SUB-COMMITTEE ON STABILITY AND
LOAD LINES AND ON FISHING VESSELS
SAFETY
55th session
Agenda item 9

SLF 55/INF.2
9 November 2012
ENGLISH ONLY

**DEVELOPMENT OF PROVISIONS TO ENSURE THE INTEGRITY AND UNIFORM
IMPLEMENTATION OF THE 1969 TM CONVENTION**

Information collected by the correspondence group

Issue 7.a – Re-measurement Following Alterations (SLF 53/5, annex 4, issue No. 7; SLF 54/INF.11)

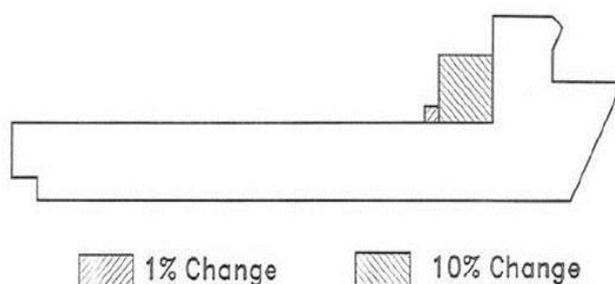
There are no universally accepted criteria for re-measuring a ship following alterations/modifications. Different administrations apply different criteria: tonnage changes of unity, 1%, 2%, 5% and 10% have all been quoted, which can be problematic when a ship changes flag. Even small changes in assigned gross tonnage can cause ships to exceed critical regulatory breakpoints, affecting the design and operating standards that apply to the ship (e.g. SOLAS, MARPOL, and STCW Conventions tonnage-based requirements). Further, it is unclear why a decrease in gross or net tonnage does not necessitate the re-measurement of a ship, if these parameters are to remain reflective of the ship's overall size and useful capacity, respectively.

Questionnaire responses: There was little agreement on any of the proposals, excepting the proposal to address re-measurement following tonnage decreases as well as increases if the TM Convention is amended for other reasons, with which most respondents agreed. Regarding the proposals related to establishing criteria based on the percentage of tonnage change, one respondent who disagreed observed that for a ship of 150,000 gross tonnage, a 1% change means 1,500 gross tonnage (6,000 m³), another expressed support for using 2% for ships of less than 500 gross tonnage, another suggested a combination of percent tonnage change and changes to other information on the ITC69, and another urged that practical limits be adopted. Regarding the proposals related to re-measurement after a decrease in tonnage without necessarily amending the TM Convention, two respondents observed that this could be left to the Administration, with one noting that requiring such a re-measurement would contradict article 10(1), and another observing that use of a 1% criterion for both tonnage increases and decreases might be the simplest solution. Regarding the proposals related to requiring re-measurement following any change affecting information on the ITC69, two respondents noted this approach would effectively require re-measurement regardless of an increase or decrease in tonnage, another commented that reissuance following tonnage decreases could be at the owner's option, another commented that not reflecting such changes on the ITC69 could be problematic in situations involving a change of flag or owner, two expressed the view that only appreciable changes should necessitate certificate reissuance, and another commented that small changes within agreed to limits should be recorded/noted on the existing certificate. Regarding the proposals that the matter be left to the flag Administration, one respondent commented to the effect that for reasons of uniformity, all Administrations should follow the same rules, another expressed the view that a 1% tonnage increase should be the official mandatory IMO cutoff, and another commented that clarification would be helpful provided that the limits developed are

Proposals: The group considered nine proposals. One proposal recommended establishing a 2% criterion for ships of less than 500 gross tonnage and a 1% criterion for larger ships. Two proposals recommended that any change to parameters used to calculate tonnage should require re-measurement, such that the ITC69 always reflects the ship's actual arrangements, with one of these proposals stipulating that the reissuance of the ITC69 in the event of a tonnage decrease should be at the owner's option. Another proposal recommended re-measurement after a tonnage increase or decrease of 1% or more. Two proposals recommended that the matter be left to the Administration, with one of these proposals recommending use of a 1% change in gross or net tonnage in the absence of established criteria from the Administration. One proposal recommended amending article 10(1) to require re-measurement following tonnage decreases as well as increases, if the TM Convention is amended for other reasons. Another proposal recommended that an increase or decrease in gross or net tonnage of 1% or more should require re-measurement, with changes of less than 1% noted as a remark on the ITC69 to account for cumulative changes over time. Another proposal addressed one flag Administration's approach, under which a gross tonnage (GT) increase of unity (e.g. 500 GT to 501 GT) requires issuance of a new ITC69 reflecting the increase.

Issue 8.a - Criterion for use of "existing" tonnage (SLF 53/5, annex 4, issue No. 3)

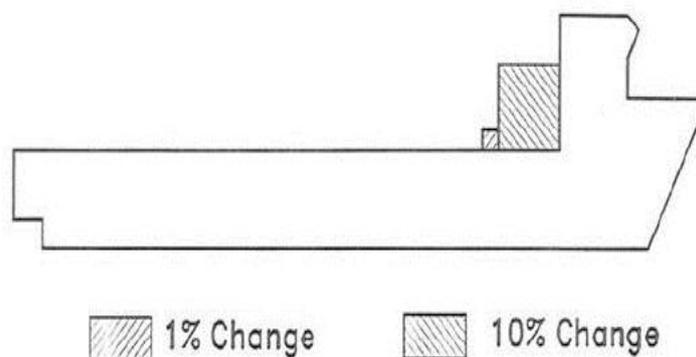
Articles 3(2)(b) and (d) grant grandfathering privileges to certain older ships that have not undergone alterations "deemed by the Administration" to be a "substantial variation in their existing gross tonnage". This provision allows a qualifying ship's owner to use the preexisting national tonnage (GRT) to apply older breakpoints in international conventions, including SOLAS and MARPOL Conventions. As described in document SLF 38/10/1, there appeared to be broad agreement that "substantial variation" meant a gross tonnage change on the order of 10%, and that a 1% change was effectively within the limit of calculation accuracy. Nonetheless, TM.5/Circ.5 established a 1% criterion for a "substantial variation" and hence the breakpoint for loss of GRT grandfathering privileges.

Questionnaire responses: A majority of respondents agreed with the proposal recommending the criterion of a 1% change in the original gross tonnage, or agreed with changes. Among those not in agreement, one respondent questioned how in situations involving flag changes, a country proves the "existing tonnage" and by which means a new flag Administration can verify that the ship has not "substantially" changed since 1994, while another commented that it is not reasonable to change provisions under which a ship operates on the basis of changes acknowledged to be within the margin of measurement error. Regarding the other proposals, one responded expressed the view that because the TM Convention is now applicable to all ships, any discussion of applying a 10% cut-off for the purpose of article 3(2)(b) has become irrelevant. Another respondent commented that article 3(2)(b) does not make a distinction about alterations to "existing" ships before or after 1994 in the context of loss of grandfathering privileges, and that amendments to the TM Convention would be necessary to include such a distinction. Another questioned whether it was relevant to continue to assess substantial variations based on GRT tonnage 18 years after the full entry into force of the TM Convention, and commented that creating such guidelines at present seems unreasonable.

Proposals: The group considered five proposals. One proposal recommended that a substantial variation in the existing tonnage be defined as one where the gross tonnage is changed by more than 1% of the original gross tonnage. A second proposal was along similar lines, but recommended including a clarification that the tonnage change should apply to both the ship's original national (GRT) gross tonnage as well as the gross tonnage (GT) measured under the TM Convention. Another proposal sought a distinction between two cases:

Figure 12 – Unified Interpretations proposal 5.c.1

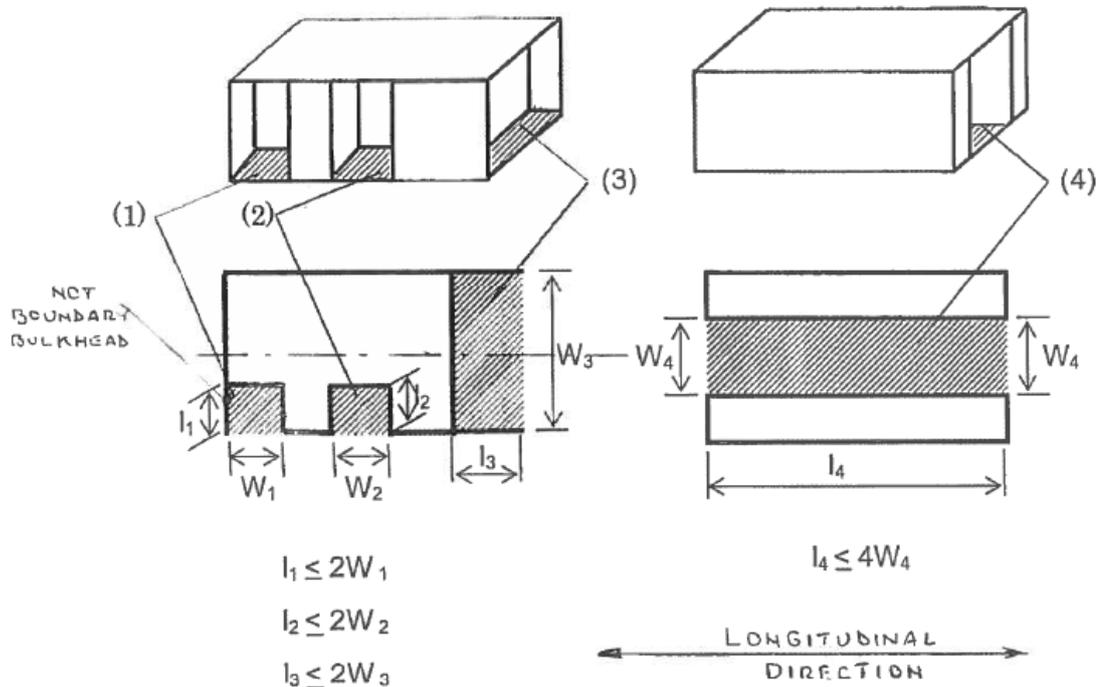
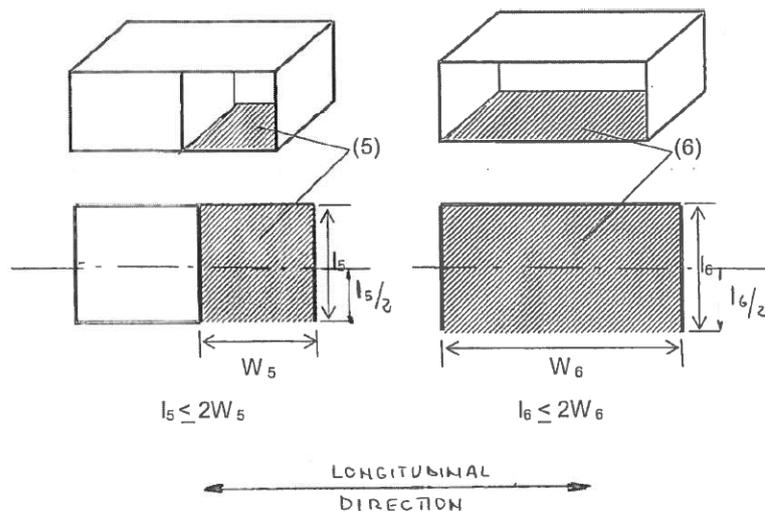
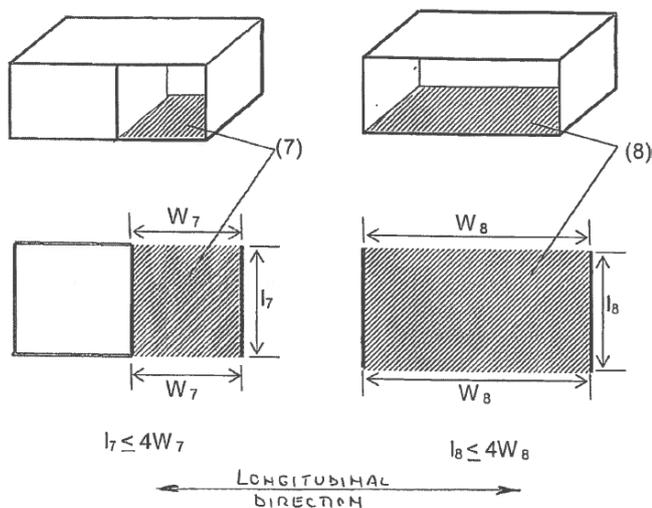
- (1) It is not a recess – Bounded by only two boundary bulkheads – It should be excluded due to the side opening.
- (2) It is a recess – Bounded by three boundary bulkheads – It should be excluded.
- (3) It is not a recess – Bounded by only one boundary bulkhead – It is a space within an erection opposite an and opening and it can be excluded only if the provision of the Reg. 2(5)(a)(i) are met.
- (4) It is not a recess - Bounded by only two boundary bulkheads – It is a space within an erection opposite an and opening and it can be excluded only if the provision of the Reg. 2(5)(a)(i) are met.

- (5) It is not a recess – Bounded by only one boundary bulkhead –
Should be excluded a space limited inboard from the side opening to one-half of the breadth of the erection ($l_5/2$), due to the only one side opening.
- (6) It is not a recess – There are not boundary bulkhead –
Should be excluded a space limited inboard from the side opening to one-half of the breadth of the erection ($l_6/2$), due to the only one side opening.

- (7) It is not a recess – Bounded by only one boundary bulkhead –
Should be entirely excluded due to the two sides opening.
- (8) It is not a recess – There are not boundary bulkhead -
Should be entirely excluded due to the two sides opening.
